**SERVICE BULLETIN****N° 139-495****DATE:** October 17, 2018**REV. :** B - May 5, 2023

**TITLE****ATA 31 - FDR AND RIPS VARIANT ULB REPLACEMENT****REVISION LOG**

**SB D51615-31-19 ISSUE 5 (20 MAY 2019)**  
**REPLACEMENT OF UNDERWATER LOCATION BEACON (90-DAY)**  
**KIT PART NUMBERS 112470, 112813 OR 112814**

**SB D51615-31-29 ISSUE 2 (10 DEC 2019)**  
**REPLACEMENT UNDERWATER LOCATOR BEACON (90-DAY)**  
**DIMPFR UPGRADE KIT PART NUMBER 112813**

**Figure 2 – 90-Day Beacon Mounting Arrangement**

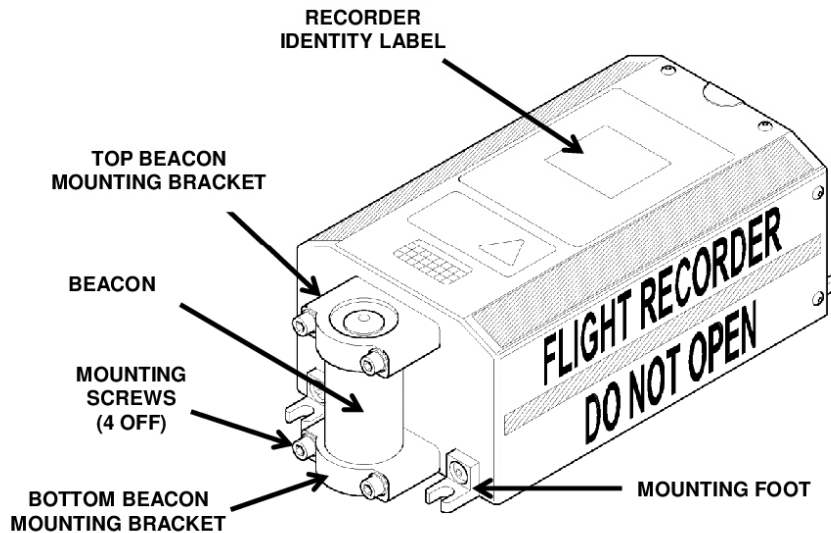
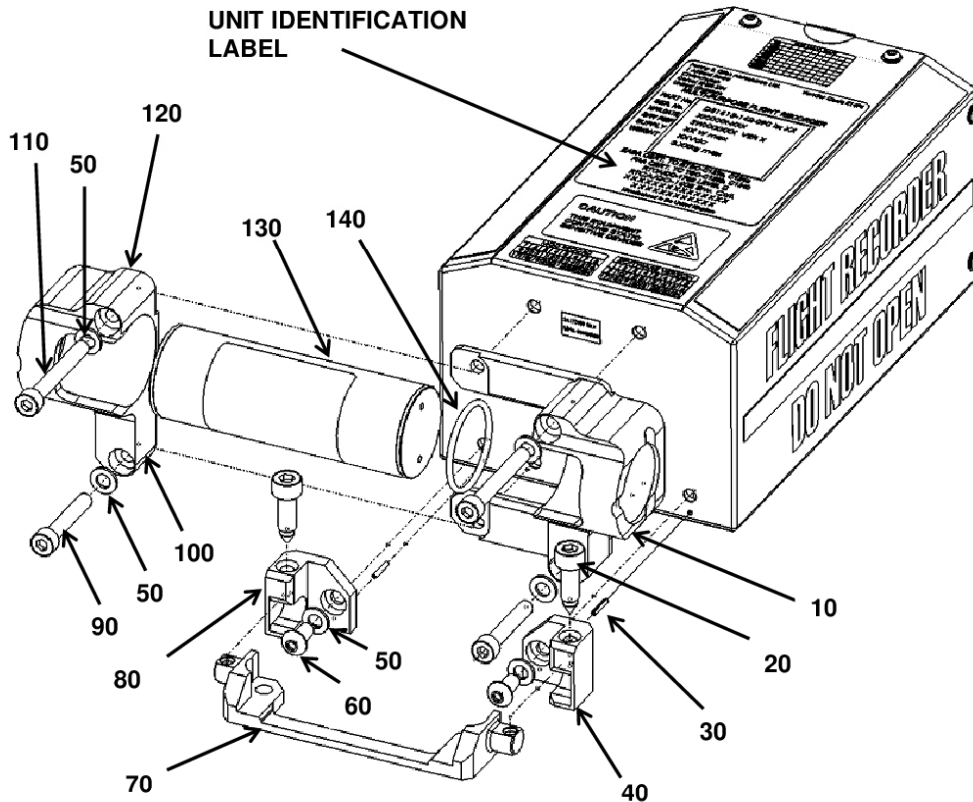
#### 1.1 Beacon Removal (Refer to Figure 1)

- 1) Remove the recorder from the Aircraft.
- 2) Remove and discard the four existing mounting screws which secure the current ULB top and bottom mounting brackets.
- 3) Remove and discard the existing ULB and mounting bracket assembly.
- 4) Remove and discard the two screws and washers which secure the two mounting feet (beacon end) to the recorder external casing.

Figure 1 – Existing ULB Mounting Arrangement

- 1) Using screws (60), washers (50) & Pins (30) fit recorder retaining foot fittings (40) and (80).
- 2) Apply Loctite 222 (locally sourced) to the threads and torque tighten screws to 2.8-3.0Nm  
**Note:** The fittings are 'handed' so ensure that the correct location is selected before securing.
- 3) Secure the RH bracket assembly (10) to the recorder using one of the longer fixing screws (110) and washers (50) in the upper location.
- 4) Secure the RH bracket assembly to the recorder using one of the shorter fixing screws (90) and washers (50) in the lower location.  
**Note:** Apply a small amount of Loctite 222 (locally sourced) to both screws before tightening.
- 5) Decide on the orientation of the Beacon (130).

- 6) Fit the Silicone rubber cord (140) into the bore of the appropriate mounting bracket into which the base of the beacon (130) is to be located (see Figure 2).
- 7) Slide the beacon into the bracket firmly up against the rubber cord.
- 8) Secure LH bracket (120) to the recorder using screws (90), (110) and washers (50). See steps 3 & 4 above.

**Note:** Ensure all beacon mounting bracket parts are correctly located before tightening the mounting bracket retaining screws (90) & (110) to 6.5-7.0Nm.

**Figure 4 90-Day ULB Mounting Arrangement**

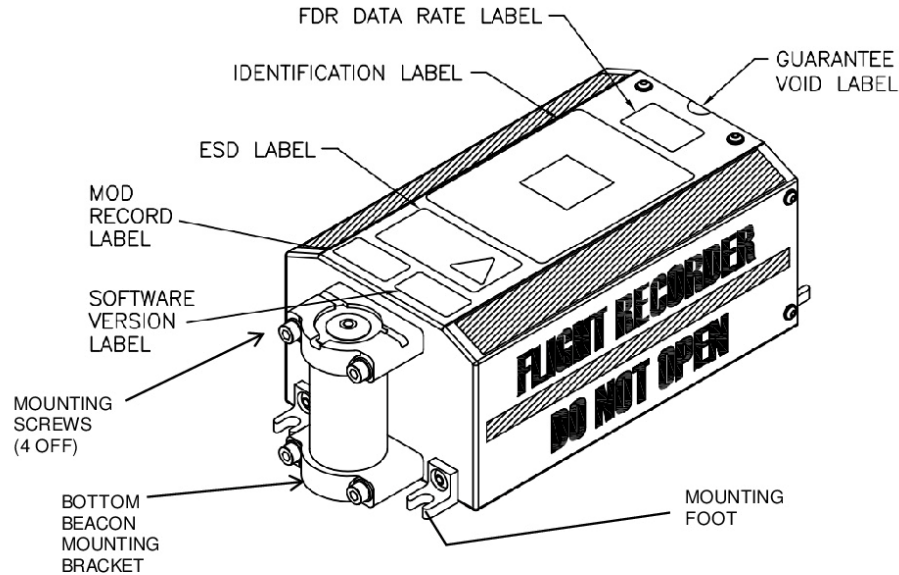
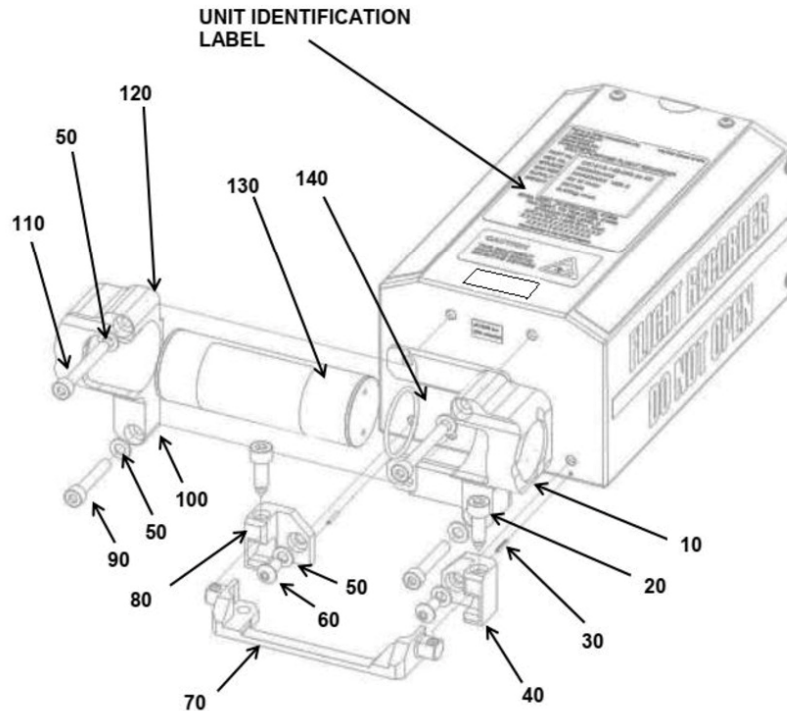
### 3.2.1 Removal of the Existing ULB

- (1) Remove and retain the four screws and washers which secure the recorder to the aircraft structure
- (2) Remove the recorder from the Aircraft
- (3) Remove and discard the four existing mounting screws (P/N W107841/0545) which secure the current ULB top and bottom mounting brackets

- (4) Remove and discard the existing ULB and mounting bracket assembly
- (5) Remove and discard the two screws and washers (P/N W107842/0512 & 680150161) which secure the two mounting foot assemblies (P/N P109302 with inserted Roll Pin P/N 250208135) to the recorder external casing (ULB end)

Figure 1 Existing 30-Day ULB Mounting and Label Arrangement

- (1) Using screws (60) and washers (50), fit Retaining Feet & Roll Pin assemblies into position on the rear face of the Recorder unit
- (2) Apply Loctite 222 to the threads and torque tighten screws to 3.9 - 4.3Nm

- (3) Secure the RH bracket assembly (10) to the recorder using one of the longer fixing screws (110) and washers (50) in the upper location
- (4) Secure the RH bracket assembly to the recorder using one of the shorter fixing screws (90) and washers (50) in the lower location

- (6) Fit the fluorosilicone seal (140) into the bore of the appropriate mounting bracket into which the base of the beacon (130) is to be located (refer to Figure 2)
- (7) Slide the ULB into the bracket firmly up against the seal
- (8) Secure LH bracket (120) to the recorder using screws (90), (110) and washers (50). See steps 3 & 4 above

Ensure all ULB mounting bracket parts are correctly located before tightening the beacon bracket retaining screws (90) & (110) to between 6.5 and 7.0Nm.

**Figure 2 Identification Label Placement**

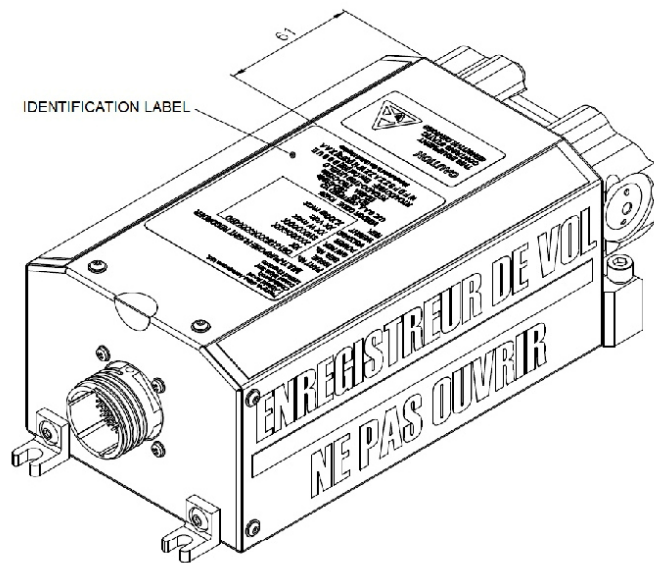
Carefully apply the new identification label (supplied as part of the 90-Day ULB Upgrade Kit) to the top surface of the Main Cover centrally, approximately 61 mm from the bottom edge of the Main Cover (see *Figure 2*). Ensure the identification label is securely fitted.

Figure 3 MOD Record Label Placement

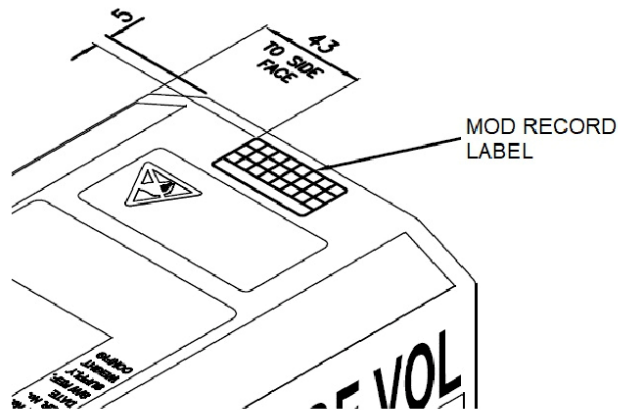
Carefully apply the Modification label centrally below the ESD label, approximately 5mm from the bottom edge and 43mm from the side face of the Main Cover (see *Figure 3*).

Units upgraded from D51615-142 Issue 2 MOD 0 Build Standard (or earlier) will require a strike through of MOD 10 on the MOD Record Label to indicate this upgrade.
